# Staff Report to the Western Weber Planning Commission

Application Request: Request for preliminary approval of Anselmi Acres Subdivision, consisting of 37 lots located

Agenda Date: Tuesday, July 11, 2023

Exhibit A: Preliminary plan showing phasing.

Exhibit A Preliminary Plan showing phasing

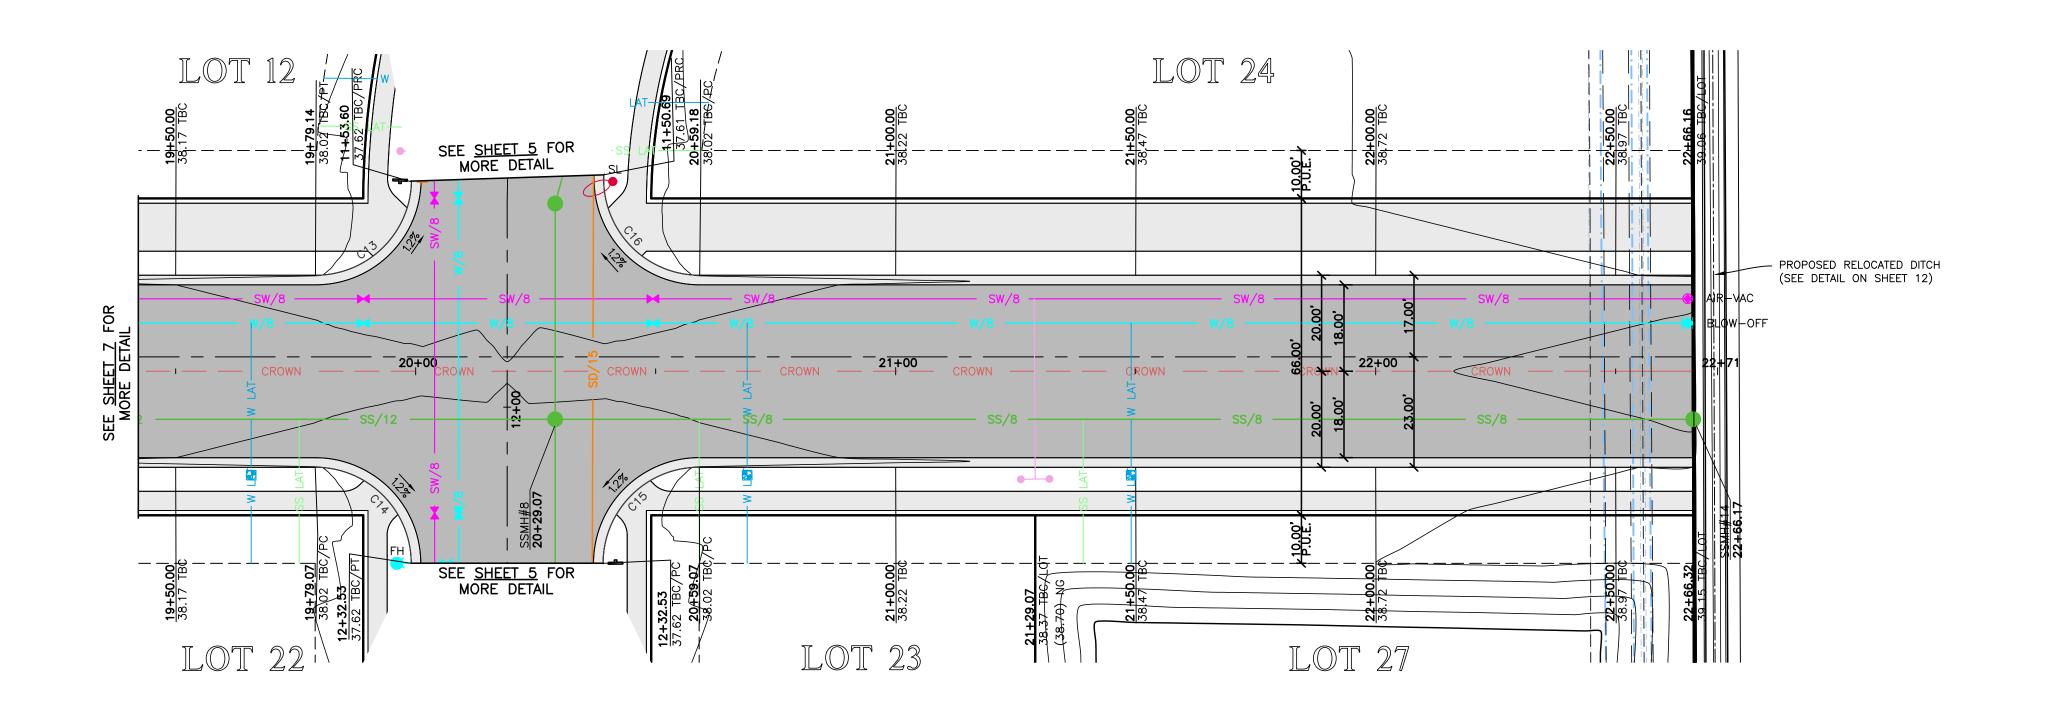
On June 13, 2023 the Western Weber Planning Commission tabled a decision on a request for preliminary subdivision approval so that the applicant could present a phasing plan at the next meeting. The proposed phasing plan is shown on the following page for consideration.

Staff recommends that the Planning Commission grant preliminary approval of both phases of the Anselmi Acres subdivision. The recommendation is based on the following conditions:

- 1. The donation to the parks district listed in the development agreement will be paid by the developer before the Phase 1 subdivision plat records.
- 2. The building setback along 1400 S shall be shown on the final plat as a 37 foot front yard setback.
- 3. The final plat will reflect the development standards that were approved as part of the development agreement (eight foot side yard setbacks for dwellings).
- 4. Phase 2 will not receive a recommendation for final approval until an approved emergency egress is provided for those lots to have a second access.
